DATE: October 4, 2021

ARC REVIEW CODE: R2109131

TO: Mayor Keisha Lance Bottoms, City of Atlanta
ATTN TO: Monique Forte, Urban Planner III
FROM: Douglas R. Hooker, Executive Director, ARC
RE: Development of Regional Impact (DRI) Review

Name of Proposal: Emory Graduate and Professional Housing DRI #3378

DRI SITE PLAN

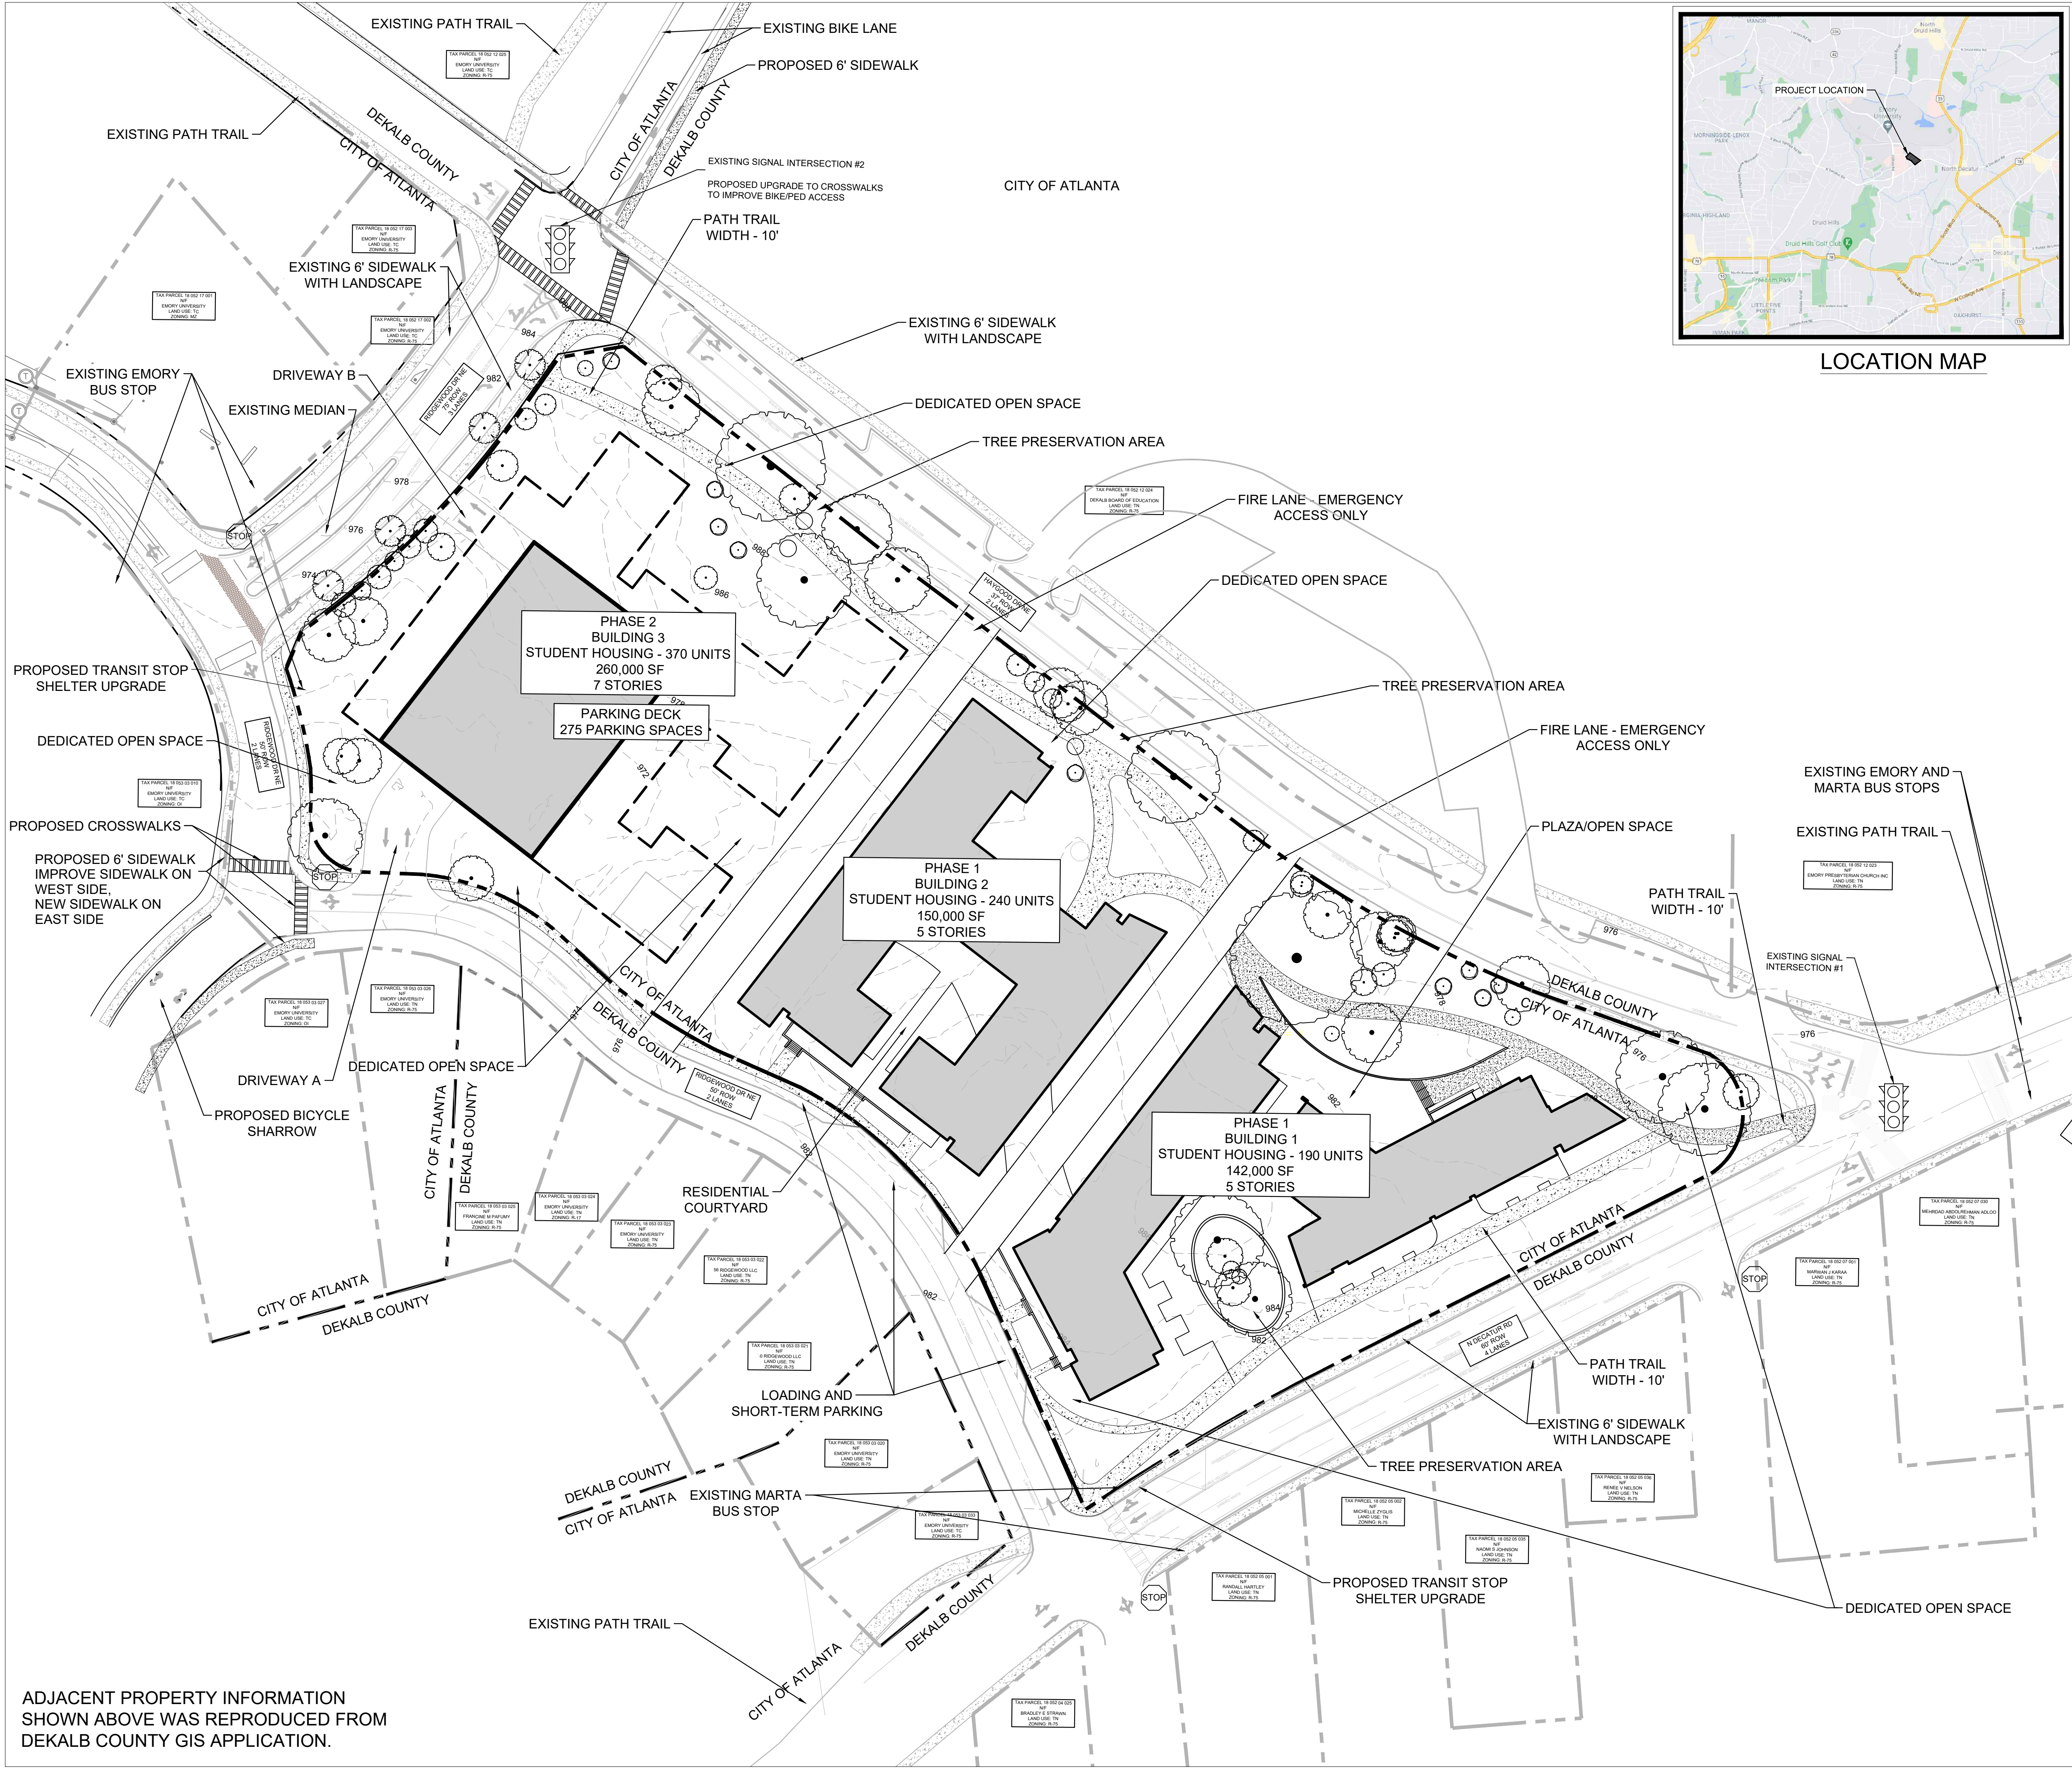
- Show where the outdoor bike racks will be placed.
 - Would also like to see the bike rack areas include some additional space for scooter parking
- It looks like they want to upgrade the Northern most intersection crossing for bike/ped. Would also like to see the SE intersection with added enhancements for bike/ped crossing, in particular to connect the Path trail across intersection.
- Consider raised crossings on Ridgewood intersections at western most intersections.
- Would like to see detail on pedestrian access through the site between buildings
- If they put commercial in the bottom floor, they should also install a mid-block crossing across Haygood to get to the high school because kids will want to access the commercial space.

Neither the site plan nor the USGS coverage for the project area shows any streams on or near the property. Any unmapped streams identified on the property may be subject to the City of Atlanta's stream buffer ordinance, and any unmapped State waters identified on the property will be subject to the State 25-foot Sediment and Erosion Control buffer.
